**BID TITLE: CAMERON COUNTY DANCY BUILDING HVAC UPGRADES
FISCAL YEAR2025**

BID NUMBER # 251001

Cameron County Dancy Building HVAC Upgrades – Fy2025-2026

ADDENDUM NO. 2

1 MECHANICAL/ELECTRICAL SITE PLAN
NOT TO SCALE

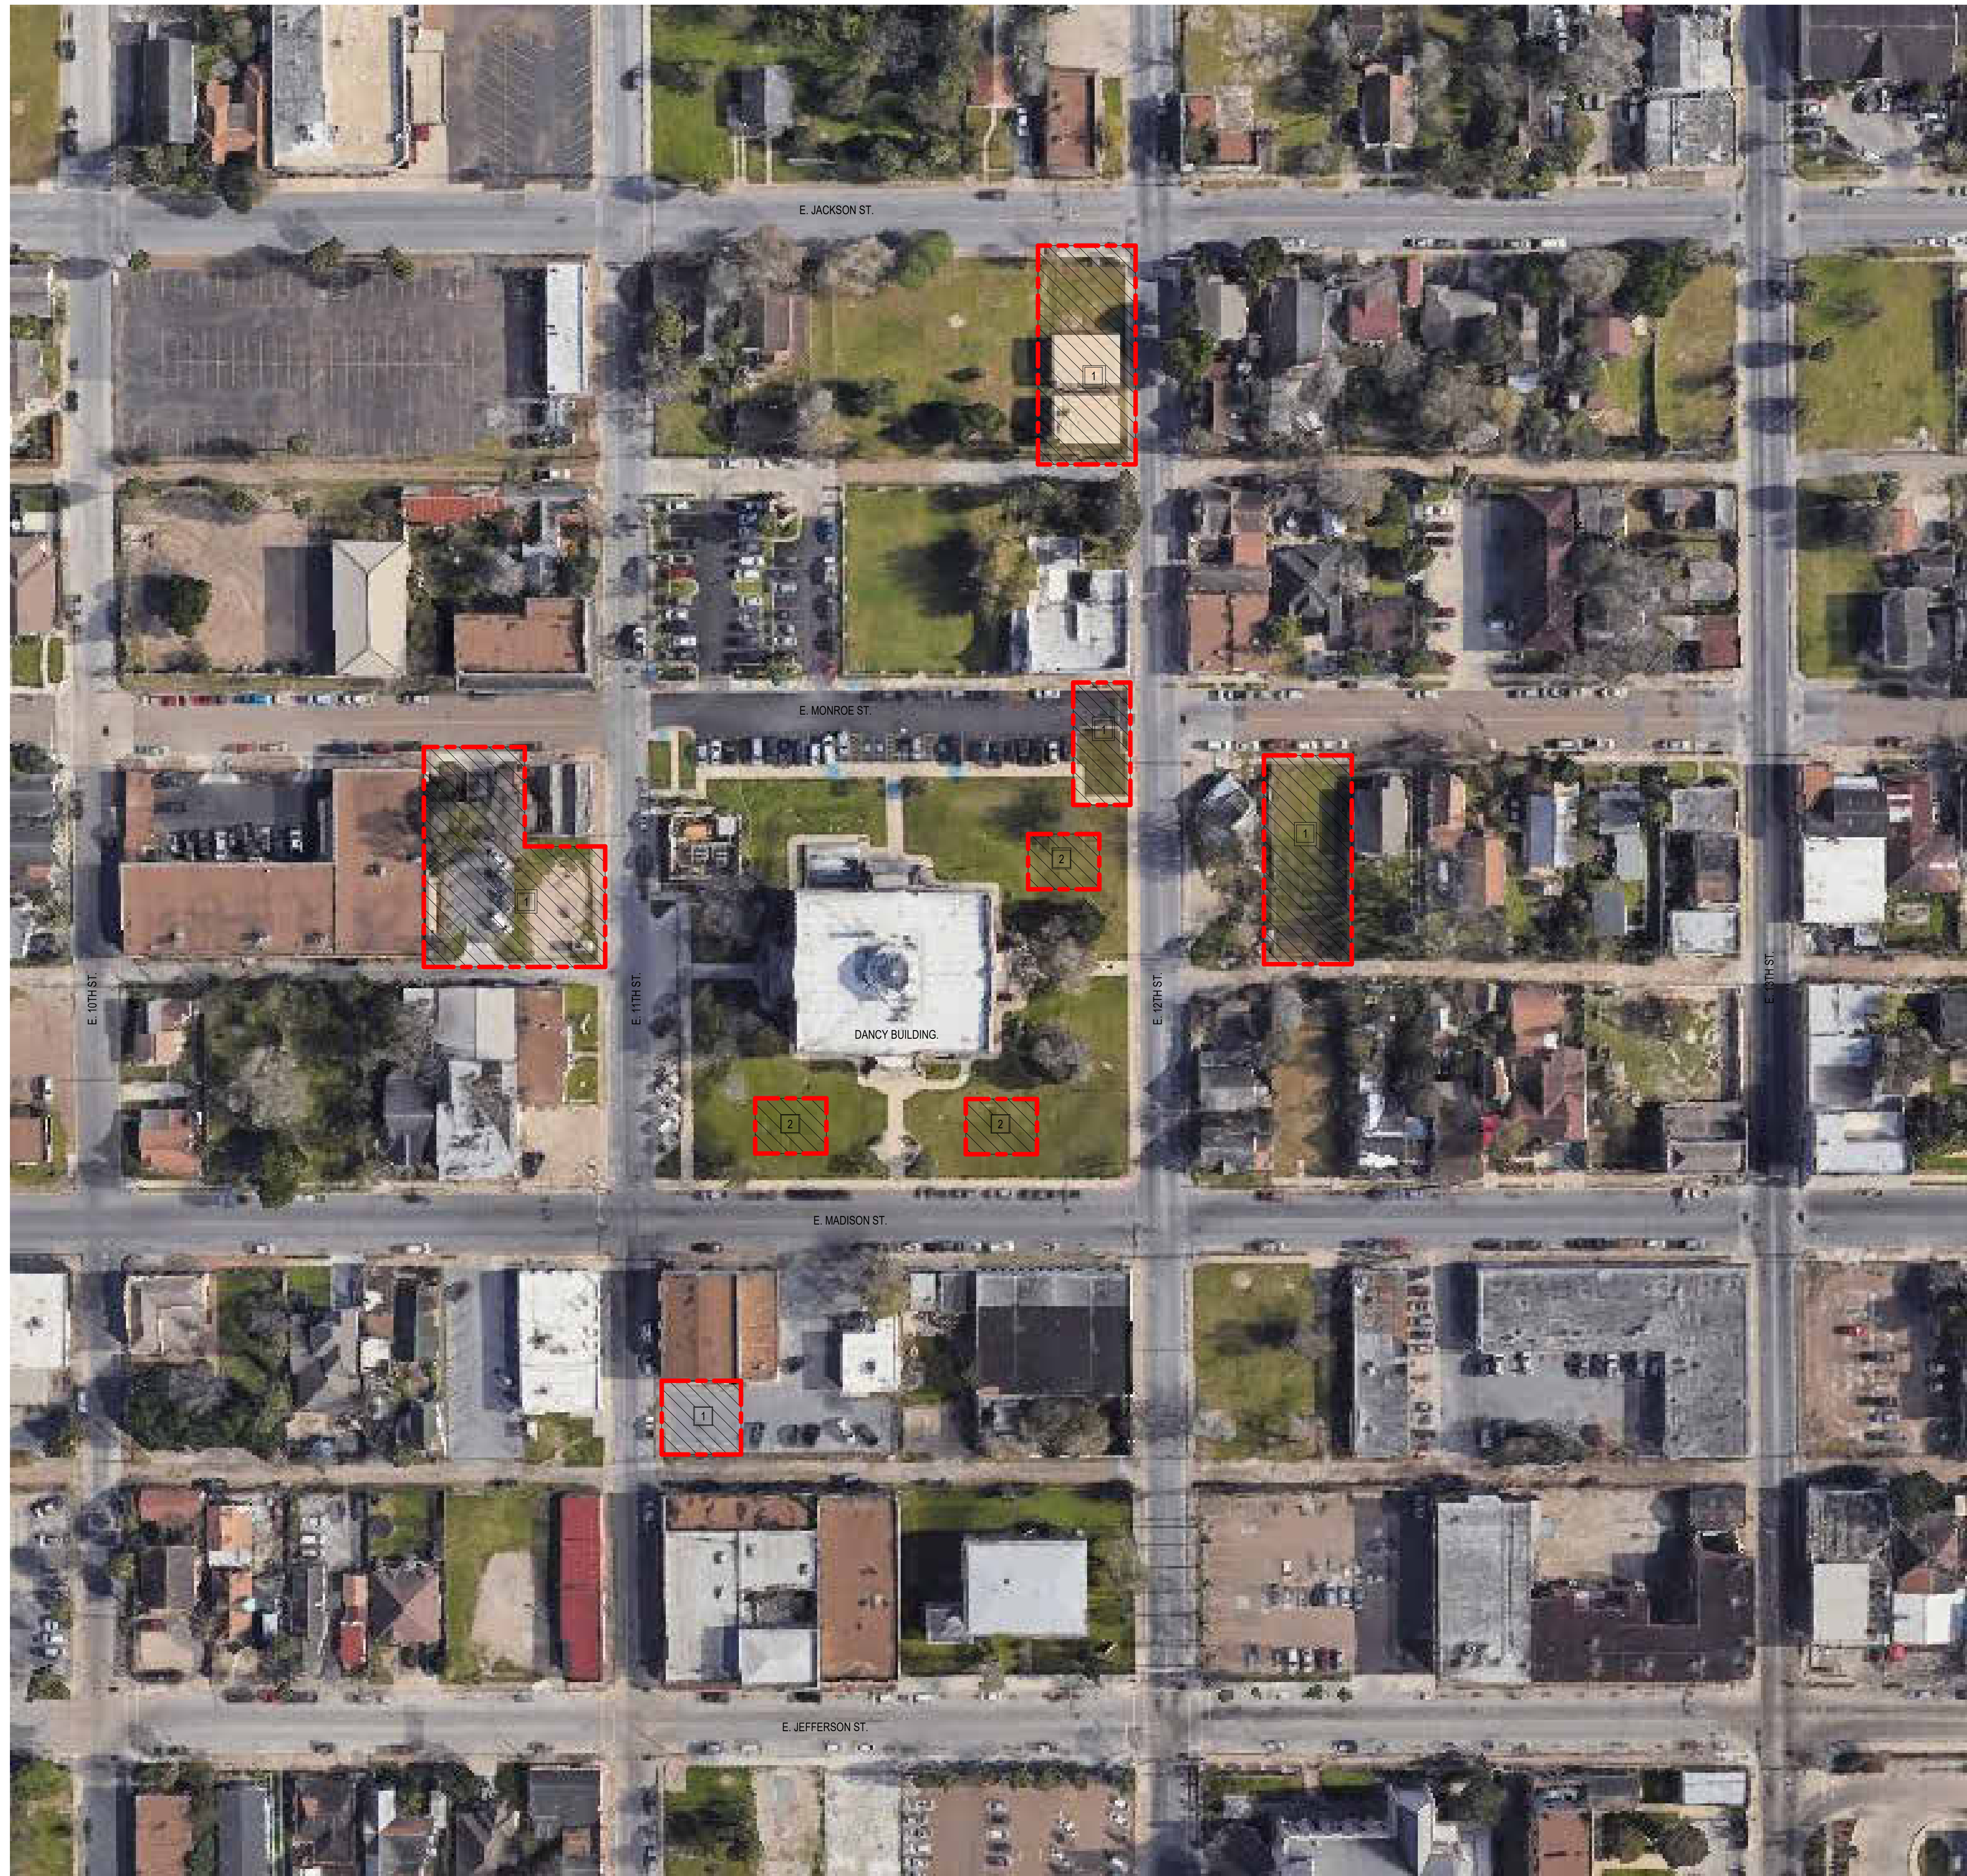
3. Added Sheet MES-1.1 Mechanical/Electrical Site Plan
 - a. Added proposed designated areas on work site for equipment & material storage, work vehicle parking, and crane placement.

- b. Clarification: Contractor shall coordinate the logistics and the quantities of how many times the Crane needs to be in and out of the site to accomplish the project requirements and include all these costs in the bid. It is strongly recommended that Contractor brings the Crane Company that he intends to use to visit the site and get familiar with the scope prior to bid.

1. THIS AREA IS DESIGNATED FOR STORAGE OF NEW HVAC EQUIPMENT, MATERIALS, AND WORK VEHICLE PARKING. PROVIDE TEMPORARY FENCE AROUND AREA AS PER SPECIFICATIONS. AFTER CONSTRUCTION IS FINISHED RETURN DISTURBED AREA TO ORIGINAL CONDITIONS INCLUDING, SO2, LANDSCAPING, IRRIGATION, SPRINKLER SYSTEMS, AND ANY OTHER EXISTING ITEMS WHETHER SPECIFICALLY MENTIONED OR NOT THAT WERE DISTURBED OR DAMAGED BY CONSTRUCTION OPERATIONS. COORDINATE WITH GENERAL CONTRACTOR.
2. THIS AREA IS APPROVED FOR PLACEMENT OF CRANE TO BE USED FOR LIFTING ROOF MOUNTED HVAC EQUIPMENT AND MATERIALS AND PLACING THEM ON ROOF. RETURN DISTURBED AREA TO ORIGINAL CONDITIONS INCLUDING, SO2, LANDSCAPING, IRRIGATION, SPRINKLER SYSTEMS, AND ANY OTHER EXISTING ITEMS WHETHER SPECIFICALLY MENTIONED OR NOT THAT WERE DISTURBED OR DAMAGED BY CRANE OPERATIONS. COORDINATE WITH GENERAL CONTRACTOR.
